From: Halah Voges
Sent: Monday, March 16, 2020 10:29 AM
To: BAYUK Dana <Dana.BAYUK@state.or.us>
Cc: NELSON Heidi <Heidi.NELSON@state.or.us>; LARSEN Henning <Henning.LARSEN@state.or.us>; Jen Mott <jmott@anchorqea.com>
Subject: RE: NW Natural, LNG Basin Questions

Figure 1c
 Simulated Capture Zones for 150-ft Long Trench in PacTerm Basin
 LNG Basin Interim Measure
 NW Natural Gasco Site

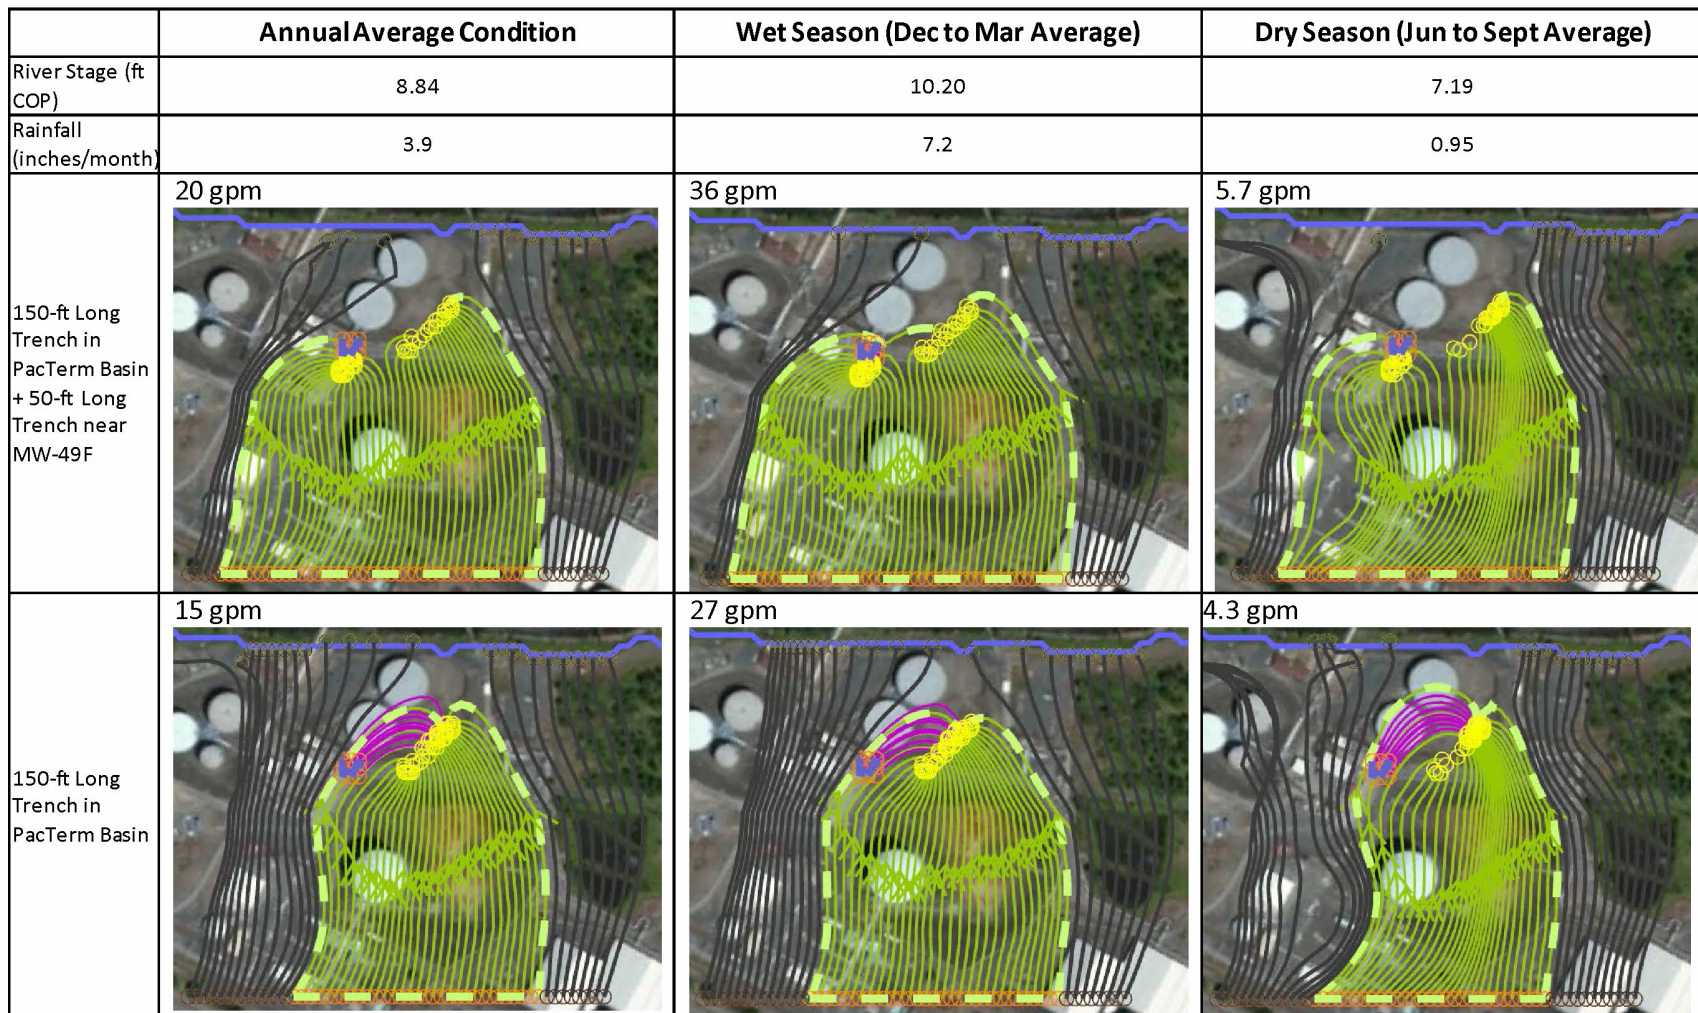
At DEQ's request, we re-ran particle tracking simulations with an expanded row of particles to fully delineate the capture zone for the two-trench scenario. The simulated capture zones for the 50-150 scenario (i.e. with a 50-ft trench near MW-49F and a 150-ft trench in the PacTerm basin) are attached. The capture zones are larger than those presented at Wednesday's meeting because of the expanded particle row. In addition, we added particles and released them from the vicinity of MW-49F to evaluate hydraulic capture for this area. The particle release locations and pathlines from MW-49F are shown in blue and purple, respectively. These results show that either a single 150-ft long trench in the PacTerm basin or the two-trench layout can provide complete hydraulic capture for the LNG Basin footprint as well as the area around MW-49F.
